# Central Coast Quarter 26 Mann Street Gosford

CONDITION B1 RESPONSE PACK

### ***Amendments to the concept proposal***

Option 3 - Drop link to RL 9.0

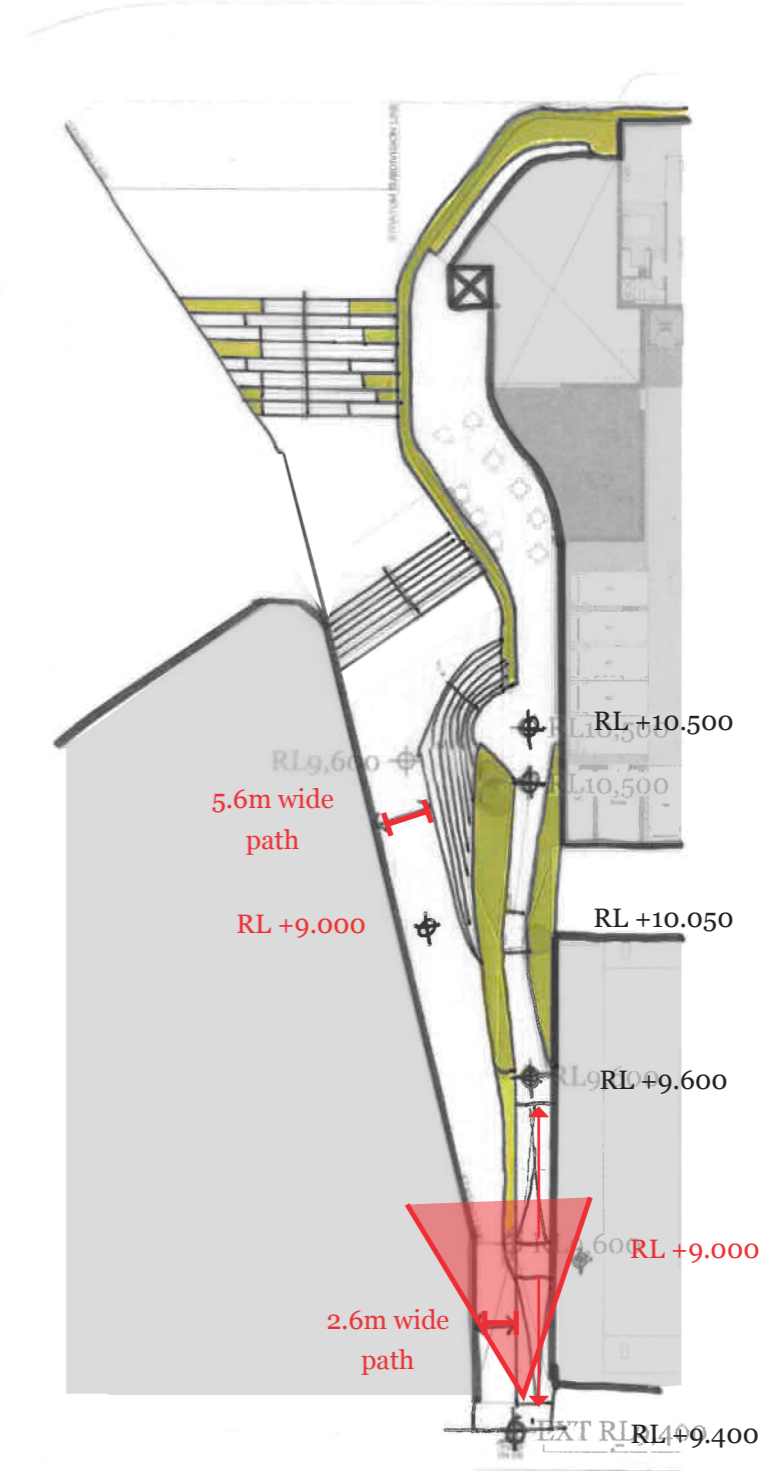
Amendment to the northern through site link or to the building envelope to show that a view line directly to the Waterfront/Leagues Club Field is retained from when standing at the boundary of the site on the footpath on Mann Street.

As an alternative option to improve the view line towards the Waterfront/Leagues Club Field, the design team has studied adjusting the through site link level to RL +9.000 and found that this resulted in a reduction of the entry path width due to additional ramping; ascending/descending complications due to existing street level at RL +9.400; and reduced pathway width due to additional steps required. In addition dropping the link down an additional 600mm provide limited additional view to the field. (when compared to option 2).

Option 4 - Eastern Tower Podium Widening (2m)

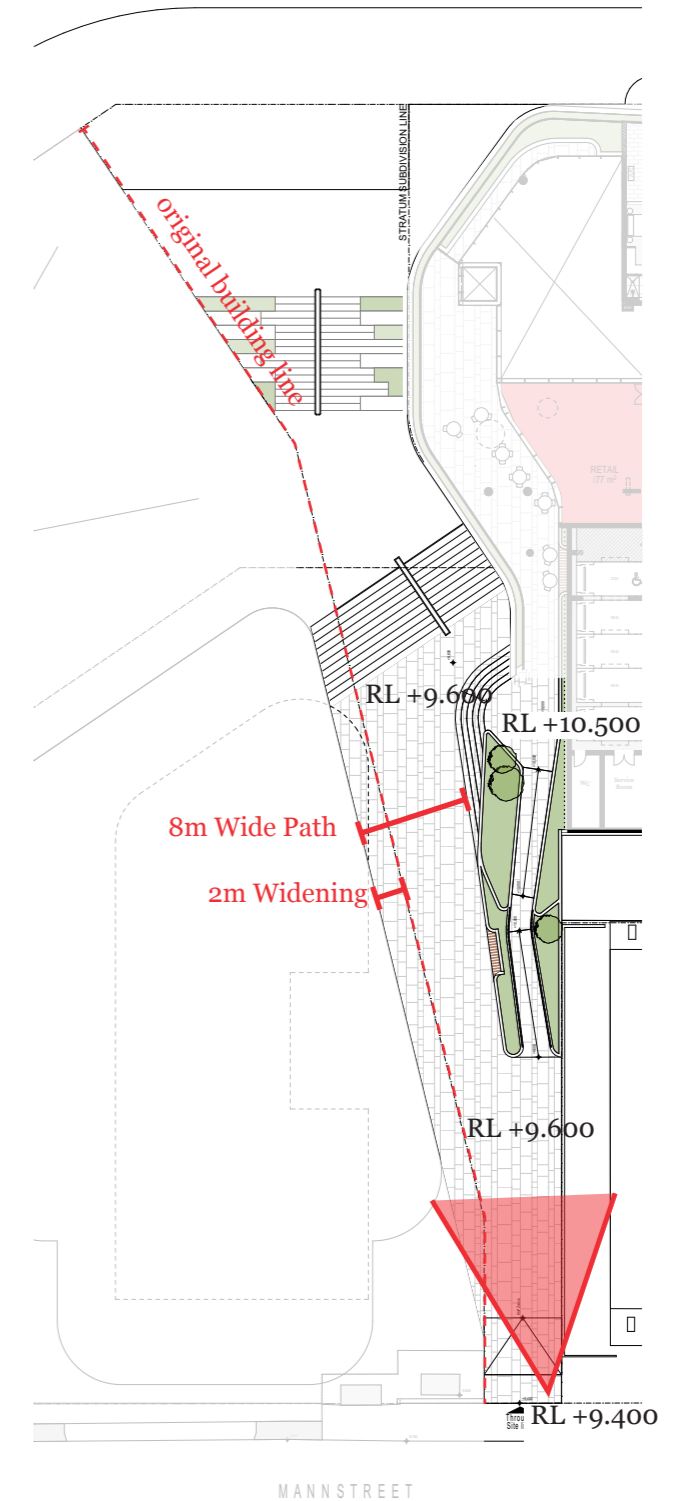
Amendment to the northern through site link or to the building envelope to show that a view line directly to the Waterfront/Leagues Club Field is retained from when standing at the boundary of the site on the footpath on Mann Street.

As an alternative option to improve the view line towards the Waterfront/Leagues Club Field, the design team has setback the facade of the Eastern Tower Podium an additional 2m. This allows a wider view and more comfortable walking path with additional expansive views of league club field and the waterfront. DKO believes this to be the most appropriate option and meets the intent of the condition.
